Comments on S-W Tentative Order

Re: Tentative Site Cleanup Requirements Order for The Sherwin-Williams Company 1450 Sherwin Avenue, Emeryville, California

Chiron Corporation ("Chiron") has reviewed the Tentative Site Cleanup Requirements Order for The Sherwin-Williams Company, 1450 Sherwin Avenue, Emeryville, Alameda County, California ("Tentative Order") issued for comment by the Regional Water Quality Control Board ("RWQCB") by letter dated December 22, 1997. Chiron's comments are provided below.

## INCREASING ARSENIC CONCENTRATIONS DETECTED IN MONITORING WELLS ON THE FORMER RIFKIN PROPERTY

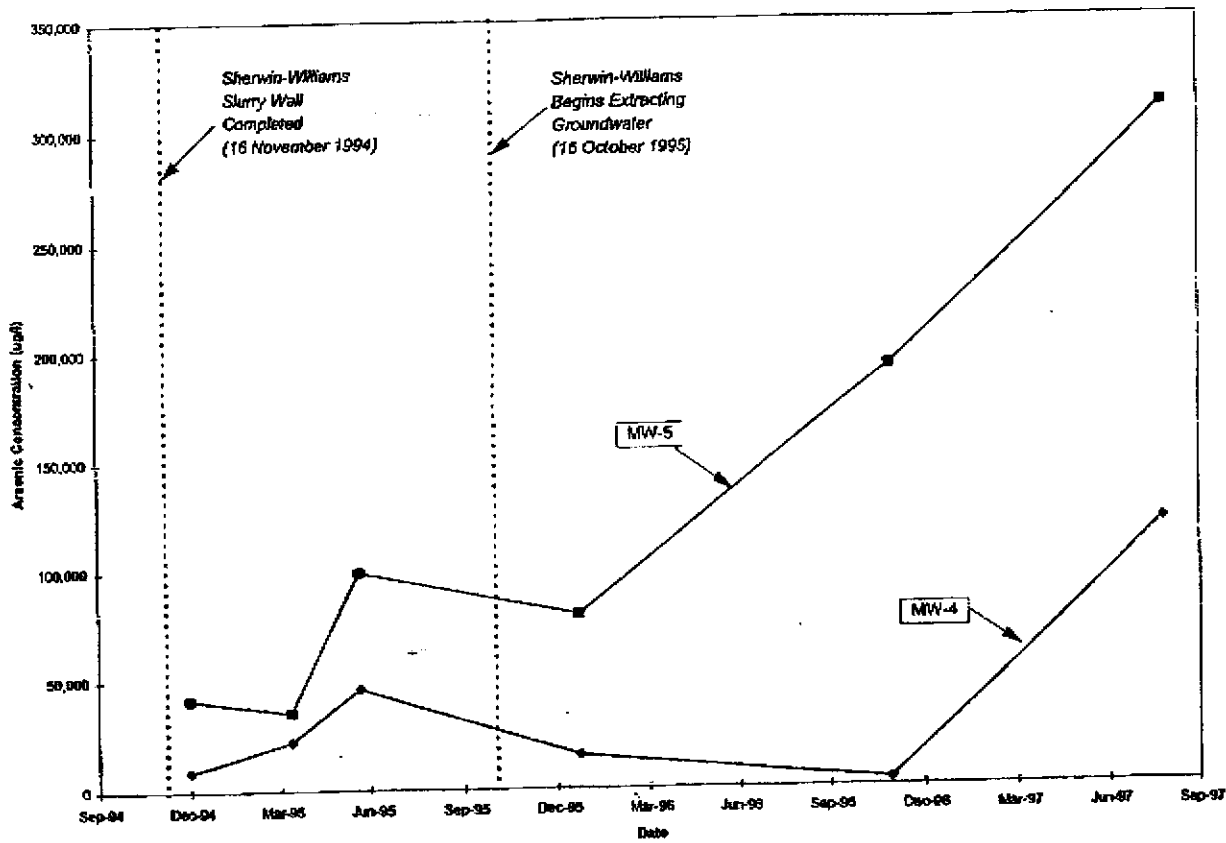
- (6) Self Monitoring Program: As RWQCB staff is aware, Chiron's original requested that Sherwin-Williams also sample and analyze groundwater from monitoring wells LF-4, LF-7, LF-8, LF-22, LF-26, MW-4 and MW-5 (see Chiron letter dated September 15, 1997). At the October 15, 1997 meeting among Chiron, Sherwin-Williams and RWQCB representatives, Sherwin-Williams agreed that it would sample monitoring wells MW-4 and MW-5 at least twice, as part of its evaluation of the existing IRMs. The results of this sampling indicate that concentrations of arsenic in monitoring wells MW-4 and MW-5, which are located on the Rifkin property outside and immediately downgradient of the Sherwin-Williams slurry wall have significantly increased (see figure attached). In order to monitor both the effectiveness of the slurry wall and other IRMs in eliminating migration of affected groundwater onto Rifkin, and the impact on Rifkin, we request that, at a minimum, monitoring wells MW-4 and MW-5 be included in the Self Monitoring Program.
